ATTACHMENT 3

PROPOSED LICENSE AMENDMENTS FOR
ADMINISTRATIVE CHANGES TO FACILITY OPERATING LICENSES
AND TECHNICAL SPECIFICATIONS

PROPOSED FACILITY OPERATING LICENSE PAGES DPR-31

PROPOSED TECHNICAL SPECIFICATIONS INDEX PAGES

FIGURE 3.1.2.5, Page 3/4 1-14a

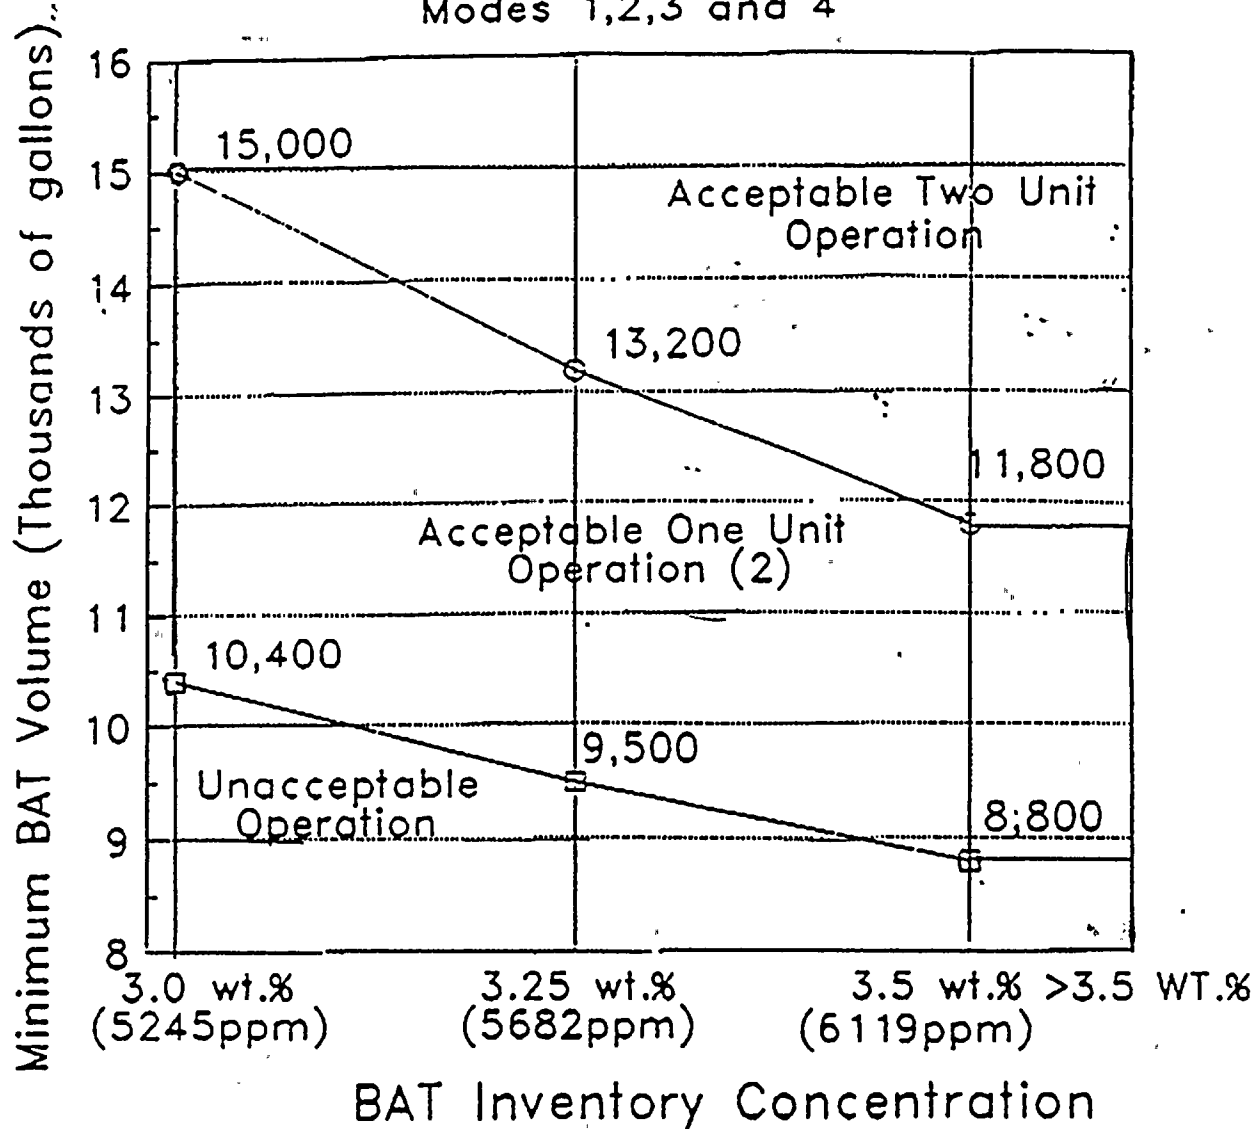
1) A minimum indicated borated water volume in accordance with Figure ~~3.1.2.5A~~ ^{3.1-2} ~~DELETE~~

2) A boron concentration in accordance with Figure ~~3.1.2.5~~ ^{3.1-2} and

3) A minimum boric acid tanks room temperature of 55°F. ^{3.1-2} ~~DELETE~~
